BULLETIN

Date:	**June 8, 2020**	Number: **CTE - 01**	Project #: **03096**
Project Name:	**Bigfoot Java**		Attached: **n/a**

Subject: **New Digital Menu Boards**
Drawings Affected:
Description/Action:

2 Panel MENU BOARD FOUNDATION

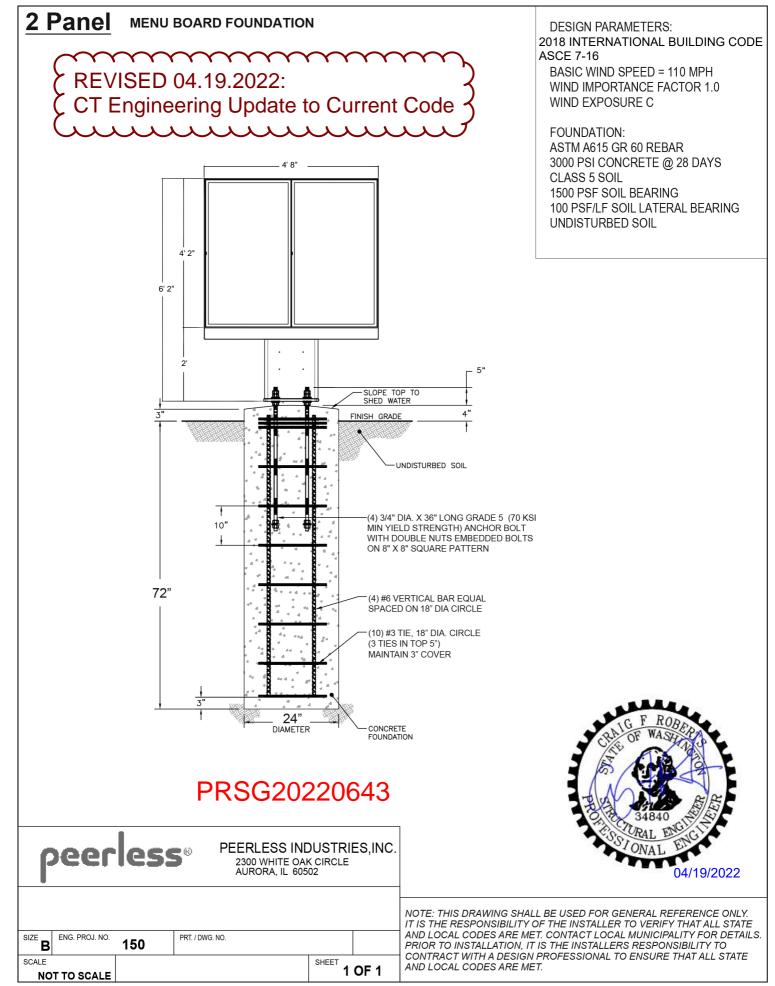
We understand Bigfoot Java would like to install new digital menu boards at several locations around Washington State. We have reviewed the intended menu board and the suggested/proposed foundation design.

Given the need for this foundation to work for all locations, we have used minimum soil parameters given in the IBC and the appropriate Wind (controls over seismic in this case) parameters giving in the ASCE 7.

We have concluded that the proposed foundation detail (see attached) is the correct design for proper support of the menu boards given the design needs.

REVISED 04.19.2022:
CT Engineering Update to Current Code

No change required for building code update.

4' 8"
4' 2"
6' 2"
2'
5"
SLOPE TOP TO SHED WATER
FINISH GRADE
3"
4"
UNDISTURBED SOIL
10"
(4) 3/4" DIA. X 36" LONG GRADE 5 (70 KSI MIN YIELD STRENGTH) ANCHOR BOLT WITH DOUBLE NUTS EMBEDDED BOLTS ON 8" X 8" SQUARE PATTERN
72"
(4) #6 VERTICAL BAR EQUAL SPACED ON 18" DIA CIRCLE
(10) #3 TIE, 18" DIA. CIRCLE (3 TIES IN TOP 5") MAINTAIN 3" COVER
3"
24" DIAMETER
CONCRETE FOUNDATION

$$d = 70.26 \ in \quad \text{Say 6ft} \qquad \underline{\textbf{Use a post embedment of 2ft dia with a 6ft depth.}}$$
